**New Castle, Colorado
Planning and Zoning Commission
Wednesday, January 24, 2024, 7:00 PM**

R2 Castle Valley Multifamily Sketch Plan Application Prior Meeting Verification from October 25, 2023

R2 Partners Sketch Plan Design Updates (Pages 8-13)

CASTLE VALLEY RANCH MULTIFAMILY SKETCH PLAN APPLICATION (UPDATE)

Site Plan Adjustments

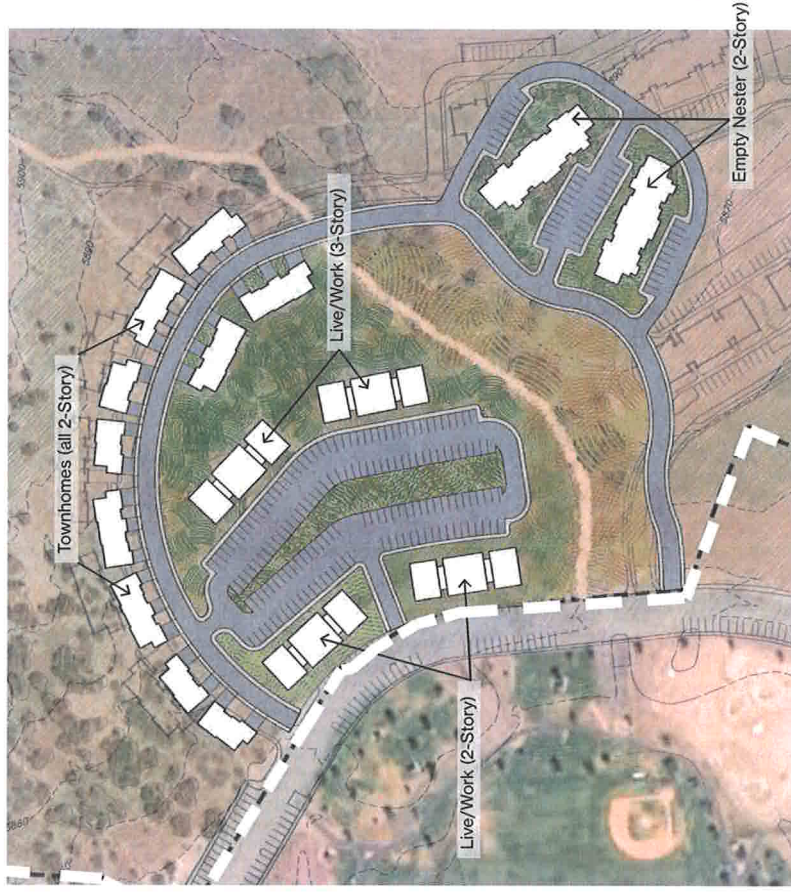
Mr. Jaynes discussed the design changes with the commission and referenced the updated sketch plan design (Exhibit A). He said there were changes made to the site plan with some architectural changes. He said their intention was to explain and explore the revised proposal with the aid of visual designs. He identified the overriding goals as providing open space and lifestyle encouraged by the development, scenic views, ample sunlight, available recreation, maintaining the neighborhood buffer, taking advantage of existing grade and respecting existing recreation corridors available to the public. He reviewed the side-by-side comparison of the original sketch plan to the updated changes (Exhibit A, Page 2). Mr. Jaynes said the visual aid highlighted the change in the footprint of the development, but the proximity to the single-family residences remained mostly the same. He said compacting the site plan allowed for a larger buffer space as well as the chance to develop on less steep grade. He said they had been working with staff and the Fire District to have a wildland fire resilient development proposal. Mr. Jaynes identified the increased compactness of the building layout with the new site plan and said the arrangement of buildings and the unit types remained largely the same (Exhibit A, Page 3). He discussed the 3-story buildings in the middle of the site plan and explained their intent was to integrate the two 'Live/Work' units in the most unimpactful way by tucking the buildings into the grade. He said the first two 'Live/Work' buildings that are 2-stories would screen the back 'Live/Work' units from North Wildhorse Drive.

- Compacted overall layout
- Shortened loop road (Town ROW)
- Eliminated 1 Live/Work building, converted 2 to 3-story Live/Work buildings
- Townhouse buildings more condensed and shorter sets of units
- Increased area of open space

Site Plan - Parking Update

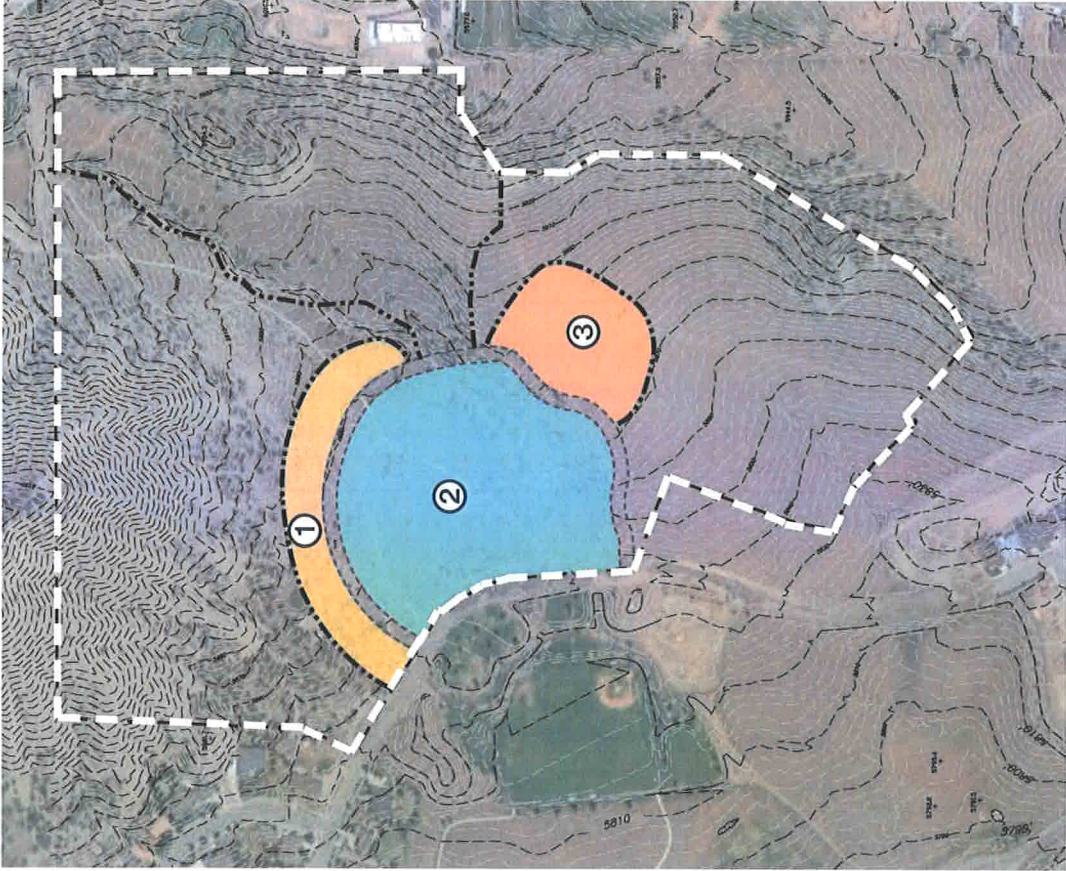
Planner Smith noted that the parking significantly changed from the original proposal. He identified the design intention attempting to screen the parking island in the middle of the site plan. Mr. Jaynes said they took advantage of the climbing grade as well to provide another level of screening. Planner Smith asked about the screening for car headlights where grading does not provide assistance. Mr. Jaynes confirmed they

planned to utilize landscaping in order to assist with car headlight screening. He clarified that a landscape buffer was planned after every 8 bays for parking.

Loop Road ROW Update

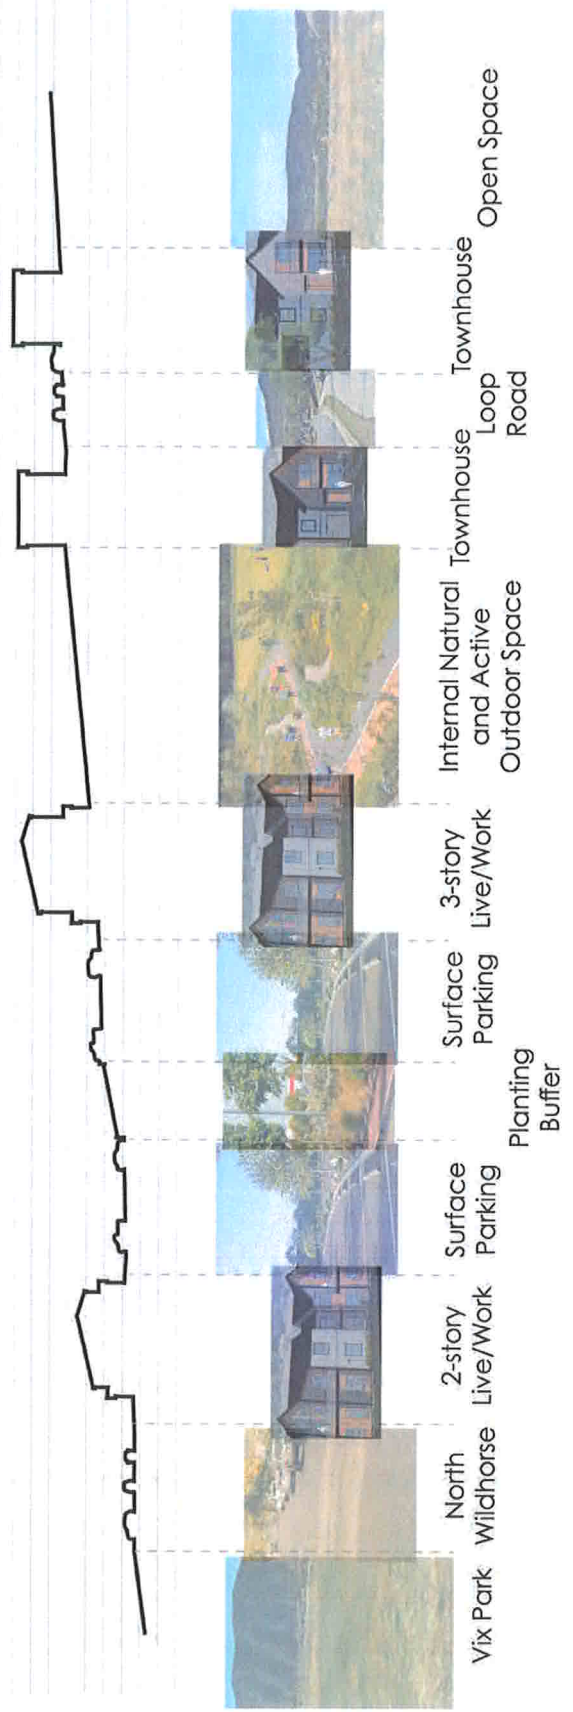
Commissioner Carey addressed the 'ring road' and asked about parallel parking options. Mr. Jaynes referenced the Loop Road Right of Way (ROW) Update visual and outlined where they planned to provide a single lane of parallel parking (Exhibit A, Page 6). Commissioner Carey noted people were going to park where they wanted and asked if the design would consider a fifty-eight-foot ROW. Public Works Director Wenzel clarified that a 58' ROW was the new street design standard and said the increased road width would allow for an additional parking lane. Commissioner McDonald asked if the design could be adjusted to move the townhomes further back into the hillside to increase the ROW. Mr. Jaynes said it was physically possible, but the steeper grade would be difficult to build on. Planner Smith shared the example of Whitetail Drive where there was a single lane for parallel parking however, he said compliance only existed due to the lots not being filled in. Commissioner Carey proposed increasing the ROW to 58' by widening the road where there was planned grassland in the interior of the site plan design.
